SUBJECT: Electric Substation Audit of PG&E San Carlos Headquarters

Enclosure: CPUC Electric Substation Audit Report for PG&E San Carlos Headquarters

CPUC SUBSTATION AUDIT FINDINGS
PG&E SAN CARLOS HEADQUARTERS
FEBRUARY 24-28, 2025

1. San Carlos Substation

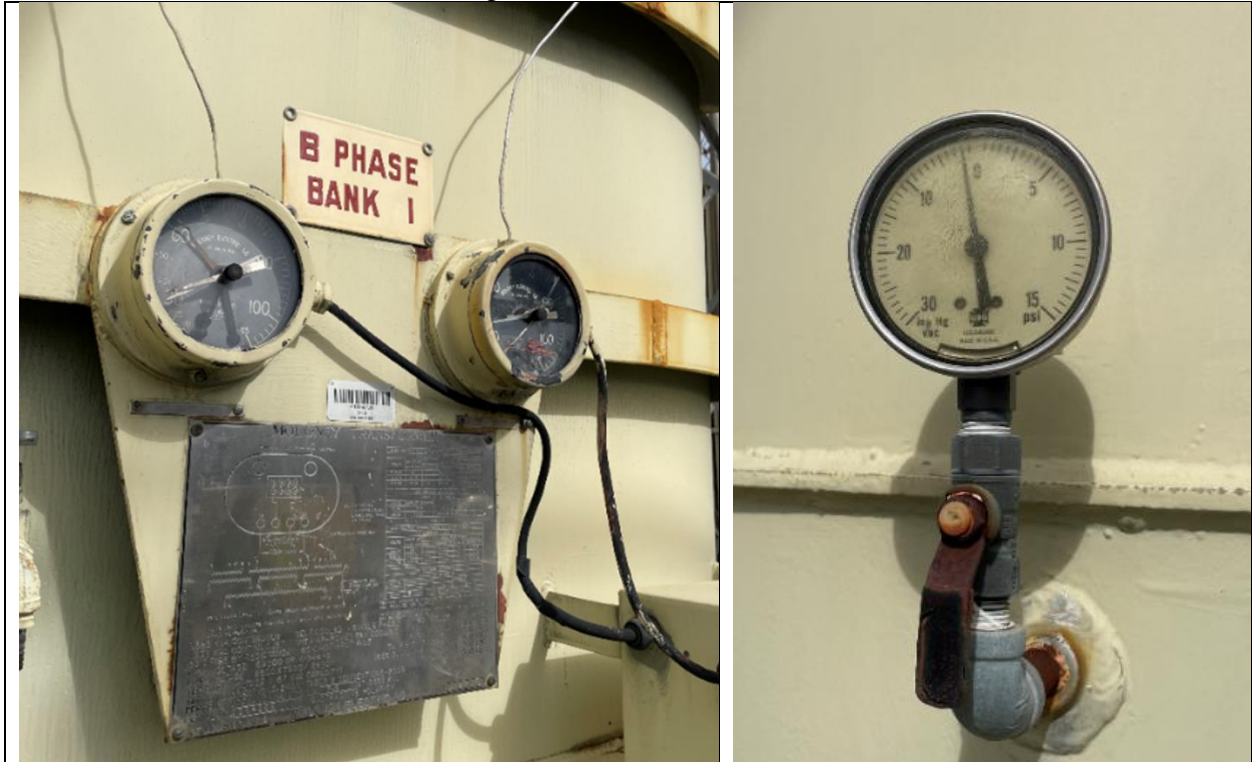
1.1. The circuit breaker for Feeder 405 has a faded counter.

1.2. The structure for Feeder 405 circuit breaker is missing bolts.

2. Belmont Substation

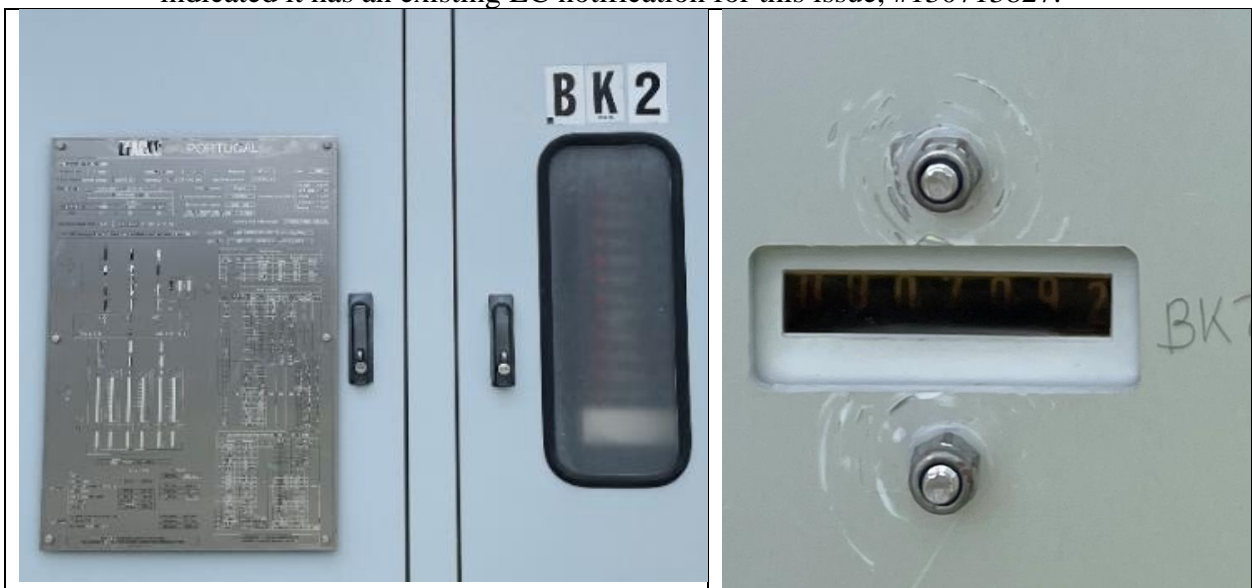
2.1. The counter for transformer bank 2 Load Tap Changer (LTC) is not legible. PG&E indicated it has an existing LC notification for this issue, #130713827.

2.2. An animal guard on the station service transformer is open. PG&E indicated it has an existing LC notification for this issue, #130712209.

2.3. Vegetation outside of station is growing over the perimeter fence.

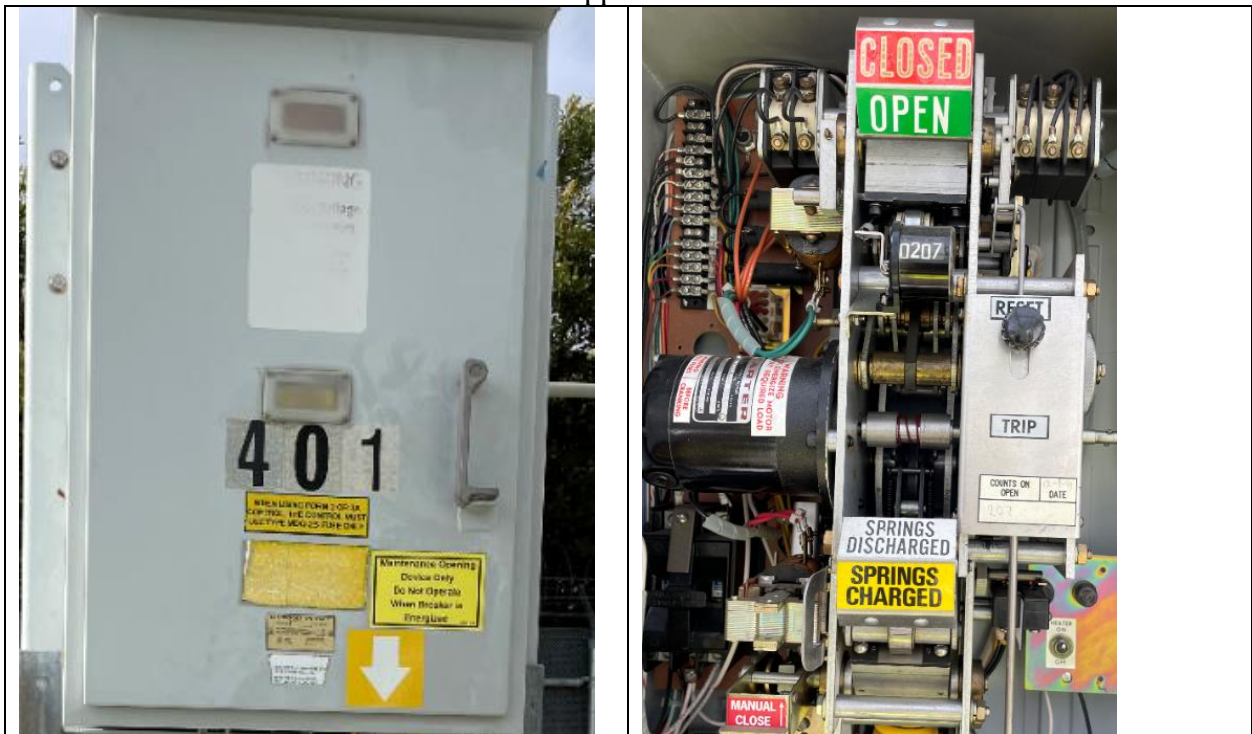
2.4. The plastic window over the semaphore on all four 4kV circuit breakers (401, 402, 403, and 406) is clouded; the color is still visible, but the letters are not. Images below of CB 401 show the issue applicable to all four 4 kV breakers.

Bay Meadows Substation

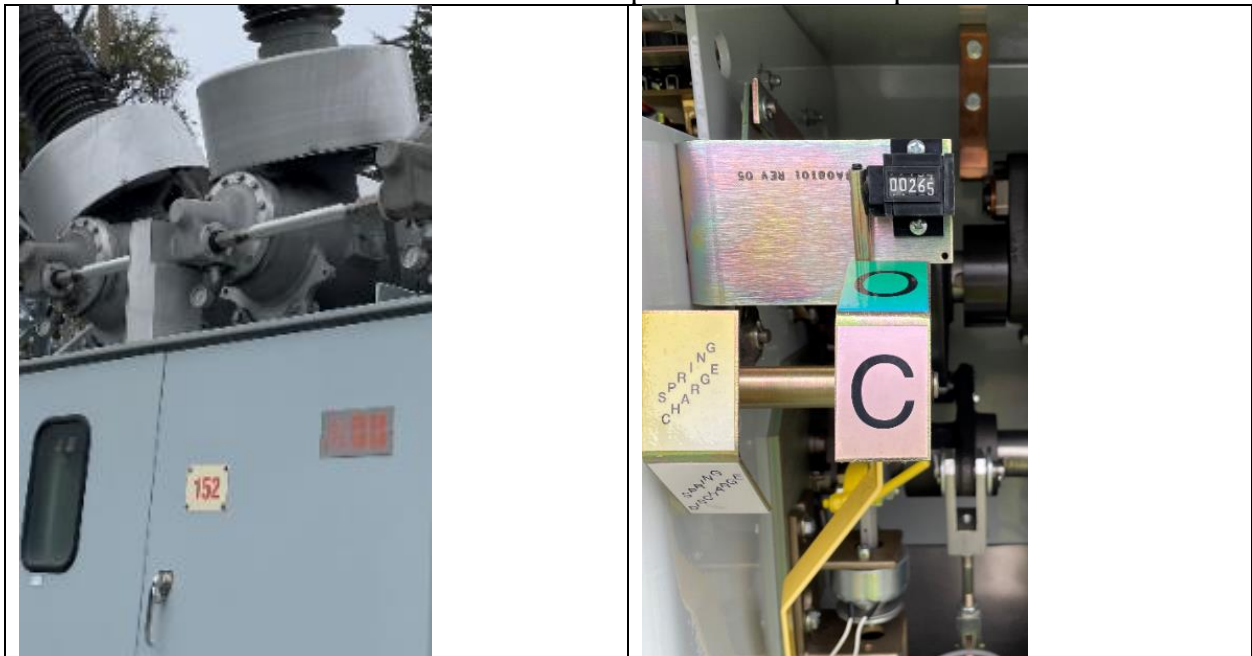
2.5. Circuit breaker 162 has a faded semaphore for the closed position.

2.6. Circuit breaker 152 has a faded semaphore for the closed position.

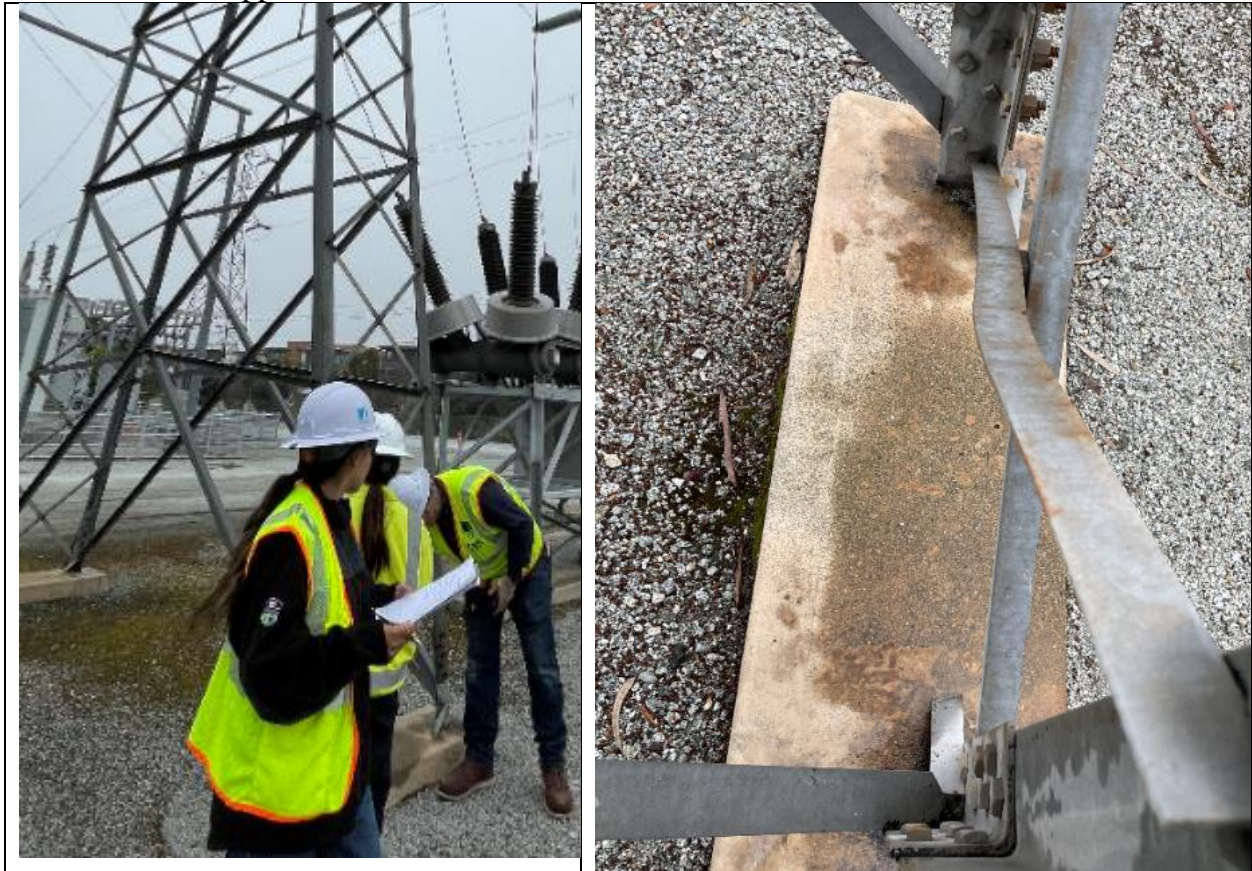
2.8. The barbed wire perimeter fence is damaged. PG&E indicated it has an existing LC notification for this issue, #130532421.

2.9. The support structure above circuit breaker 132 is bent.

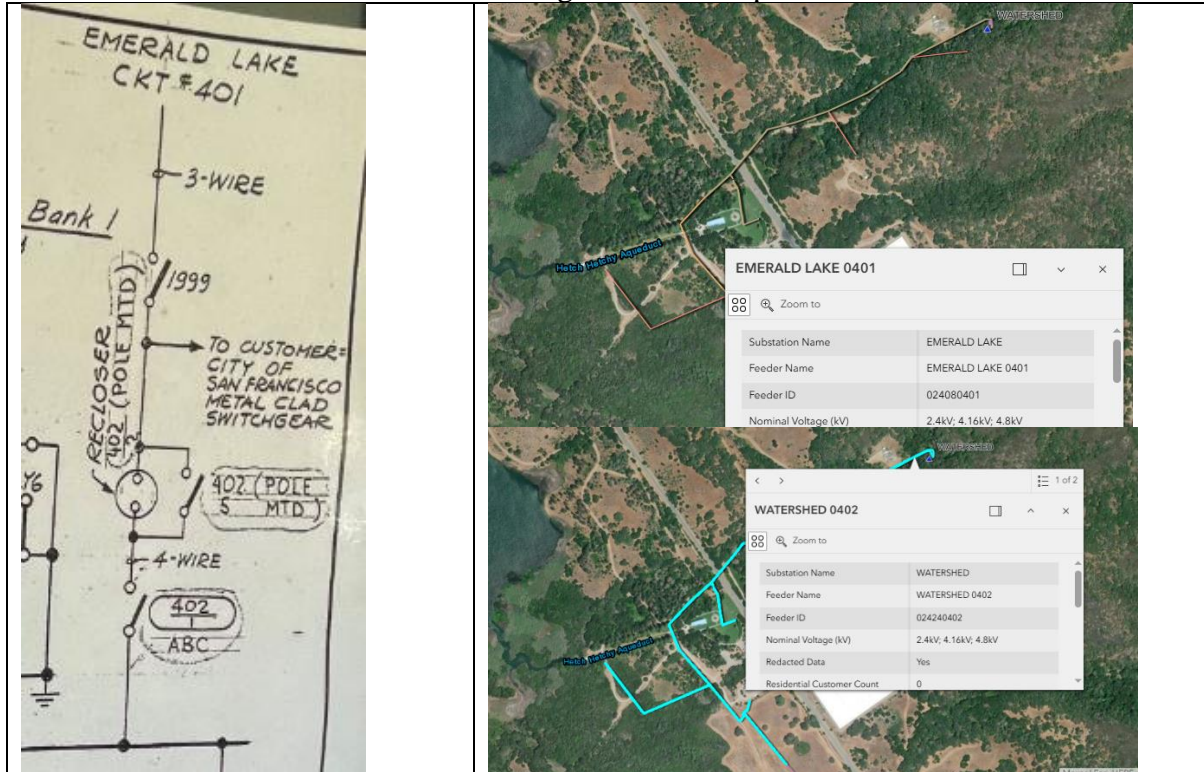
9.4. Regulator 2B position display appears to be broken based on a reading of 16 low compared to the voltage displayed on the regulator control panel.

9.5. Regulator 2C has red “Diagnostic Error” light illuminated. PG&E indicated it has an existing LC notification for this issue, #128203318.

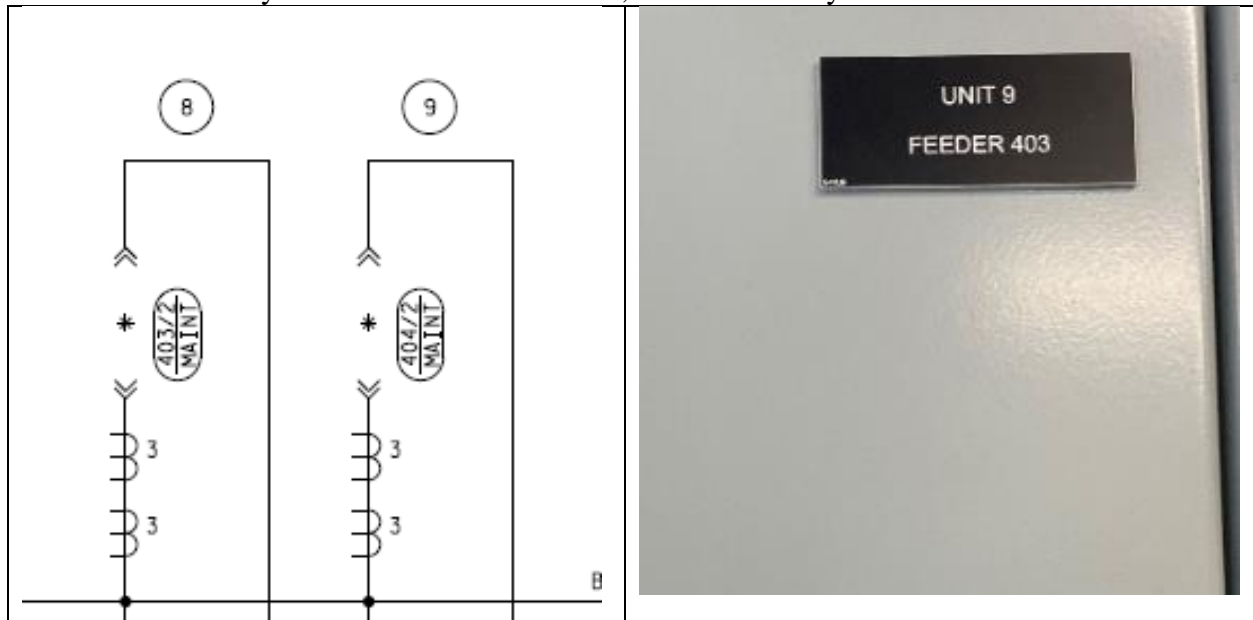
11.2. Circuit Breaker 122 has a faded semaphore for the closed position.

11.3. The counter for Circuit Breaker 182 has a misaligned last digit which prevents an accurate reading.

13. Woodside Substation

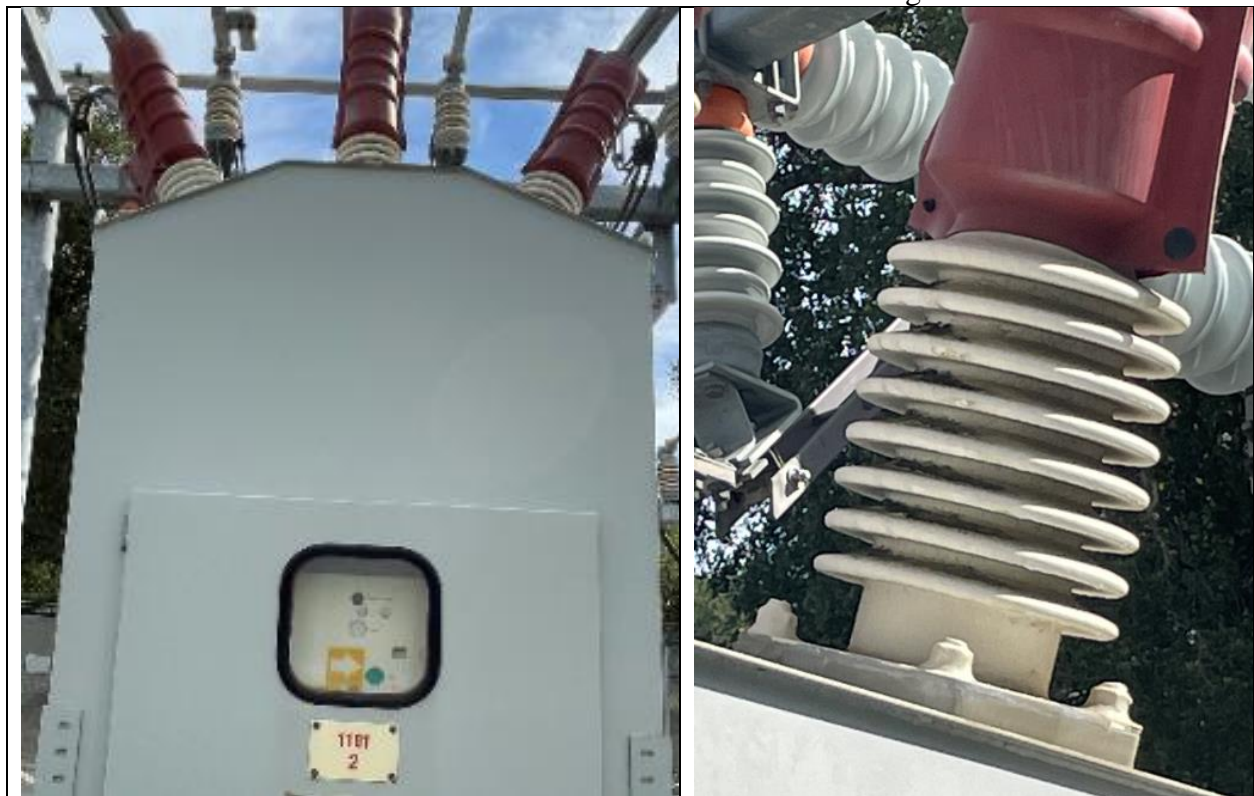
13.1. Circuit Breaker 1101 and 1102 have debris on the bushings.

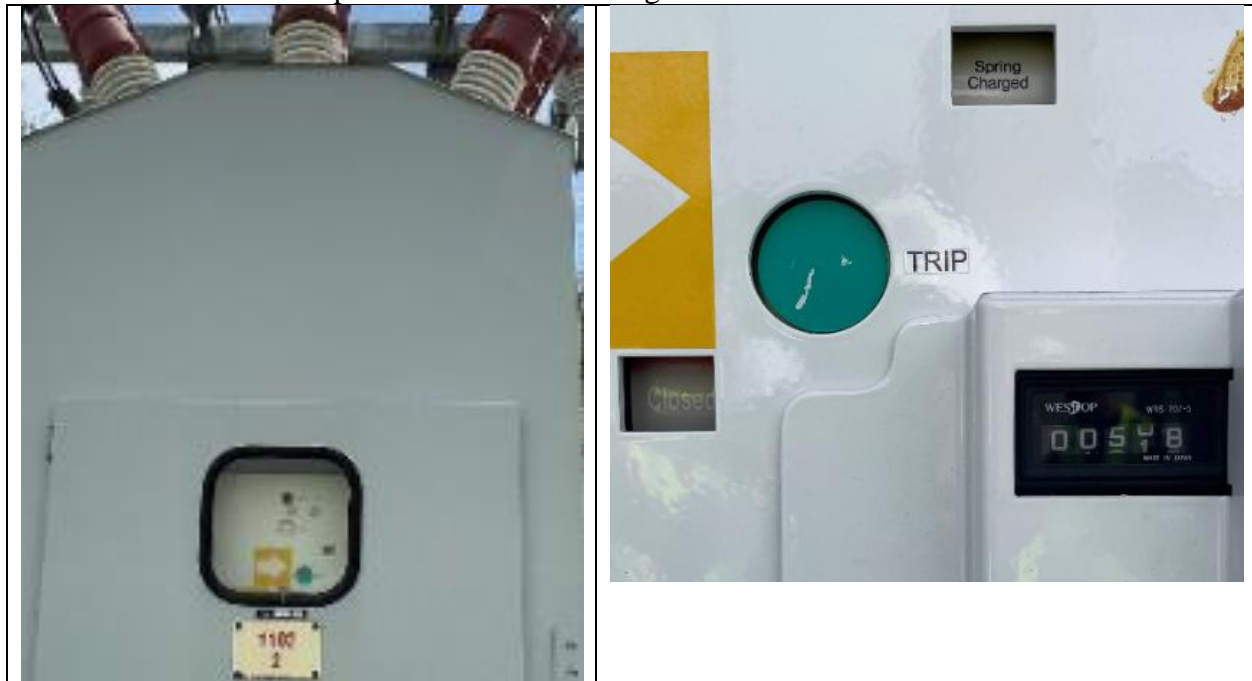
13.2. Circuit Breaker 1101 has a faded semaphore for the closed position and misaligned counter that prevents accurate readings.

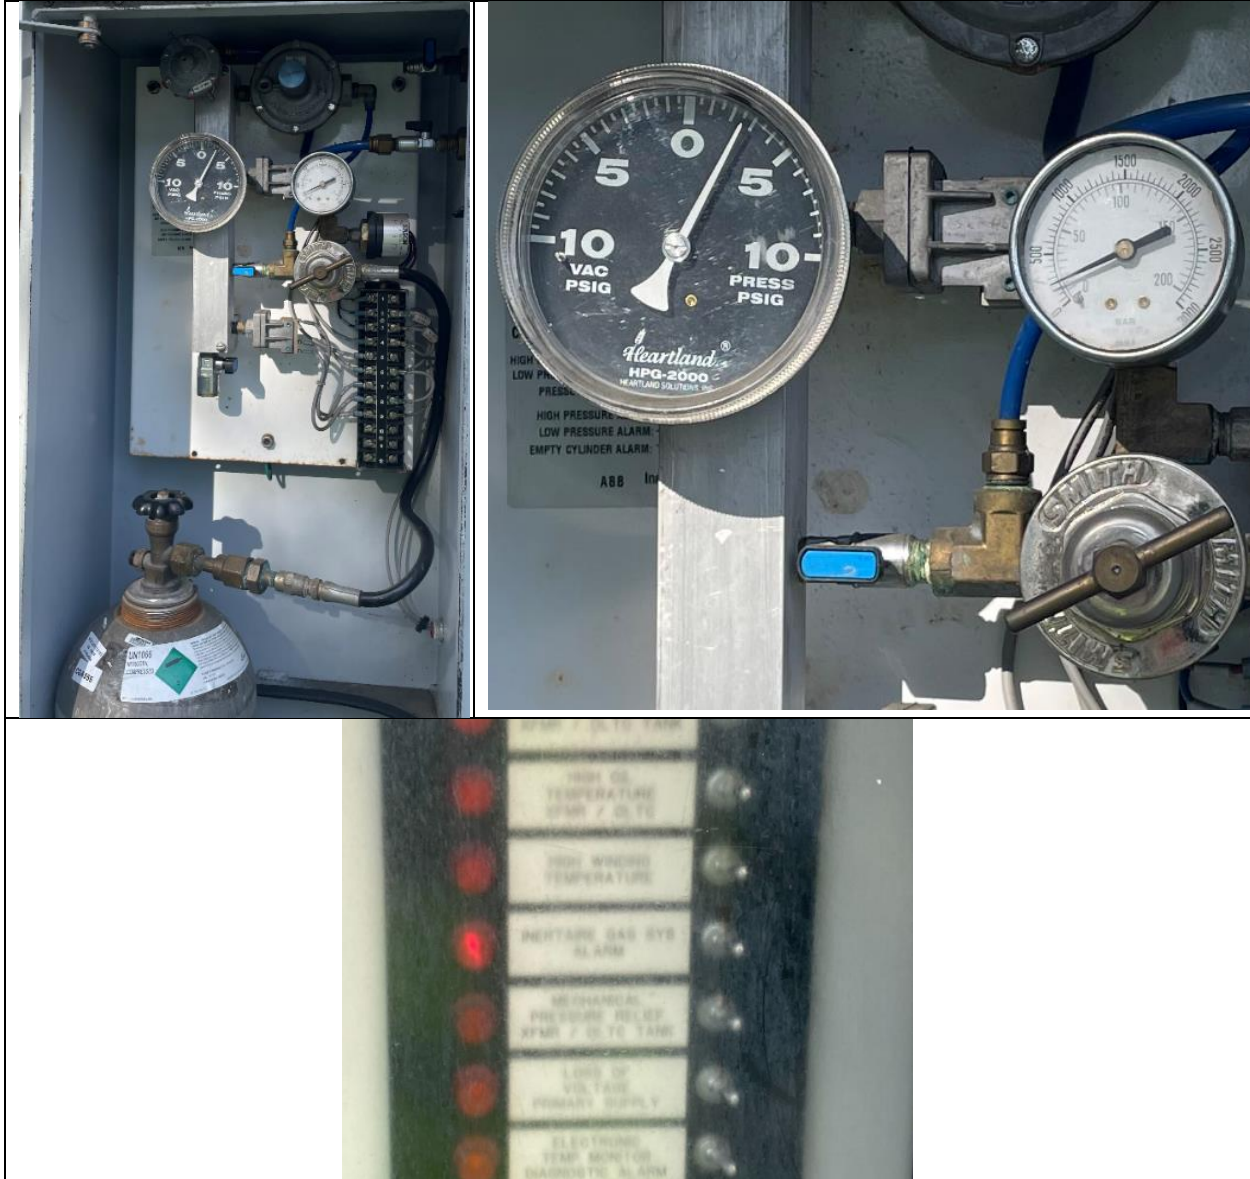
14.1. There are bird nests in transformer bank 2 radiators.

14.2. Transformer bank 3 has a damaged LTC counter: the first digit is illegible. PG&E indicated it has an existing LC notification for this issue, #130733121.
